Re: Unauthorised shed on plot no 53, A30
Nahin gr.

Re: Unauthorized shed on plot No. 53, A-30
Napier Quarter.

—PLAN PROPOSED SHED FOR—
—FLOUR MILL ON PLOT N° 53-A-30—
—NAPIER QUARTER—

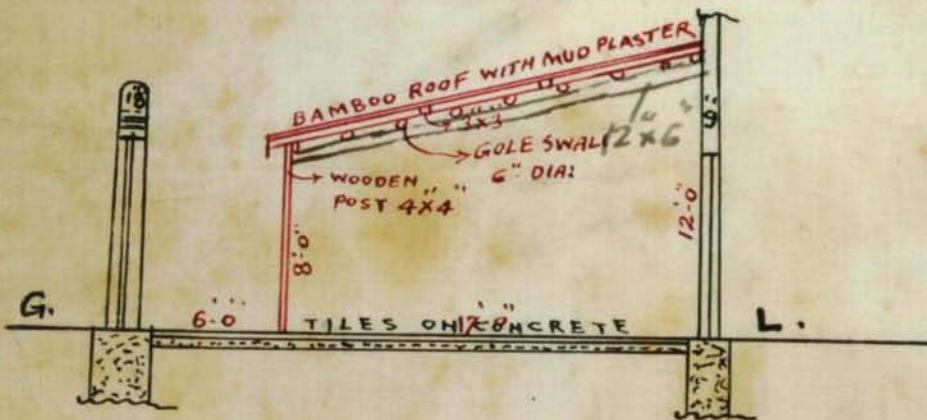
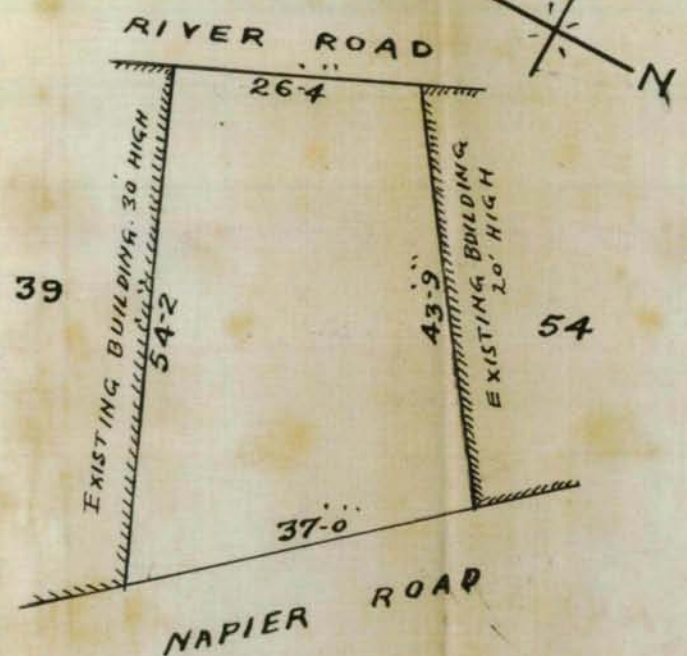
Mr. Sawaldas Chandiram per Shivji Kalidas is informed that the plan submitted for the above shed cannot be approved as the proposed shed will render the existing building insanitary and the structure is made of inflammable materials.

*Proposed shed well under
the existing building is unsatisfactory*

Applicant's Name Samuel Chandan Ram & Shuji RakeshWhether he is the owner of the plot on which it is proposed to build no.Plot under whose control Govt.Whether it is permanent or temporary permanent.The work proposed shedBuilding Surveyor's Report sr1. plot not does not stand on his
name.2. His object should be examinedDate 14/5/24A. H. Q.
Building Surveyor.

*A 12'x6' heavy mullie provided on the Port
as shown in Section to break up the big span
Portals C must be left open to sky & windows provided
for Ventilation of Room D*

He is therefore hereby directed to remove the structure.
